TX POST MIXER AMP page 16

DRAFT 'QUAD' PCB ONTO 100X100mm PCB

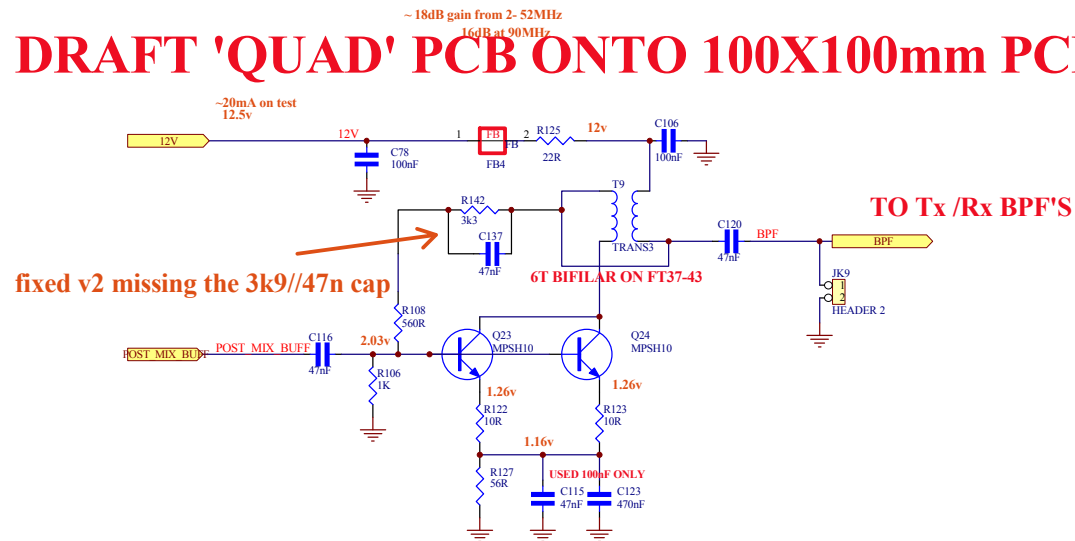
V2.0 fixed, missing the parallel cap/res in the drain, see below.

see V2.0 for corrected pcb but not yet made. at 280418
